Customer Notification

V850ES/SG3, V850ES/SJ3

32-bit Single-Chip Microcontrollers

Operating Precautions

Figure 3-1: Additional Measures in case AFCAN clock is active when waking up

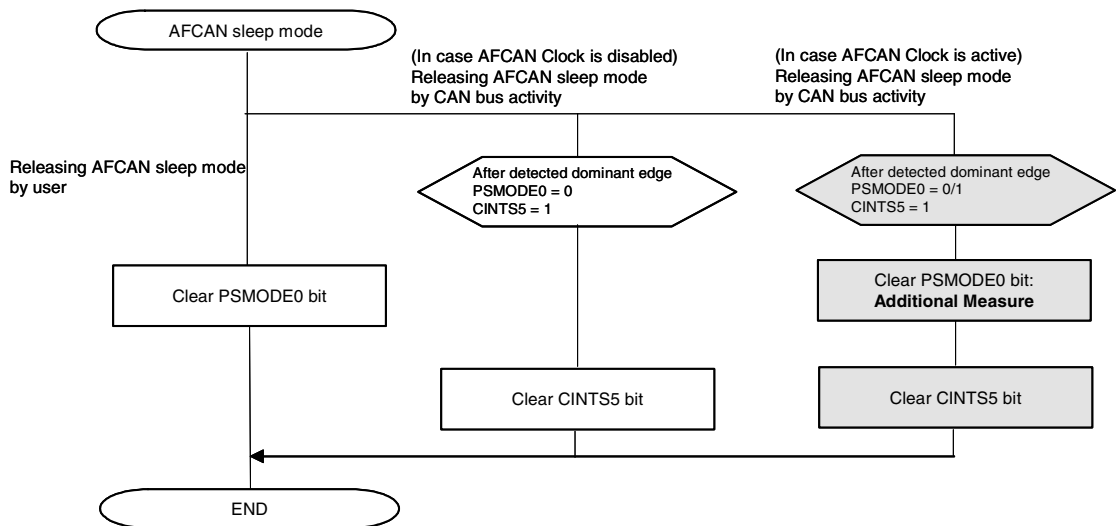
The following flowchart illustrates, how and whether additional measures have to be taken in software, to avoid the *wakeup dead time*.

No. 5	AFCAN: Sleep Mode Wakeup (Specification change notice)
<p>4. Software Improvement Hints</p> <p>4.1 Recommended WAKEUP Handling by Software</p> <p>4.1.1 Clearing the SLEEP Mode by Software</p> <p>Within the WAKEUP interrupt routine, before accessing any other register or area of AFCAN, the SLEEP mode can be canceled by software, followed by a clearance of the WAKEUP interrupt flag.</p> <p>Doing so, the AFCAN macro will start its synchronous operation right after these accesses.</p> <p>In the following C-code example, replace the objects in “<>” brackets by the hardware locations within your implementation. Use the appropriate access types, as described in the User’s Manual.</p> <pre> WAKEUP_INTERRUPT_VECTOR --> <CnCTRL_PSMODE> = 0; /* Clear SLEEP Mode */ <CnINTS_CINTS5> = 1; /* Clear INTS5 */ ... /* following other parts of interrupt routine */ ... </pre> <p>Note: Clearing INTS5 is required to get another WAKEUP interrupt anyway, by specification.</p> <p>4.2 Other WAKEUP Handling Hints</p> <p>4.2.1 Switching off the Clock Supply to AFCAN, while in SLEEP Mode</p> <p>If the clock supply to the AFCAN macro is stopped, while it is in SLEEP mode, the synchronisation of the WAKEUP works without any restriction. To achieve this, the documentation of clock controlling unit of the target device should be consulted. Usually this is performed by setting the STOP mode of the CPU of the target device.</p> <p>However, the user has to consider, that there must not be any WAKEUP condition (dominant level on the CAN-Bus), while the software is executing between setting SLEEP mode and stopping the AFCAN clock.</p> <p>4.2.2 Using a Waiting Loop within the WAKEUP interrupt routine</p> <p>Within the WAKEUP interrupt routine, create a waiting loop, which tests the capability of clearing the WAKEUP interrupt flag within AFCAN, by checking the actual power save mode.</p> <p>In the following C-code example, replace the objects in “<>” brackets by the hardware locations within your implementation. Use the appropriate access types, as described in the User’s Manual.</p>
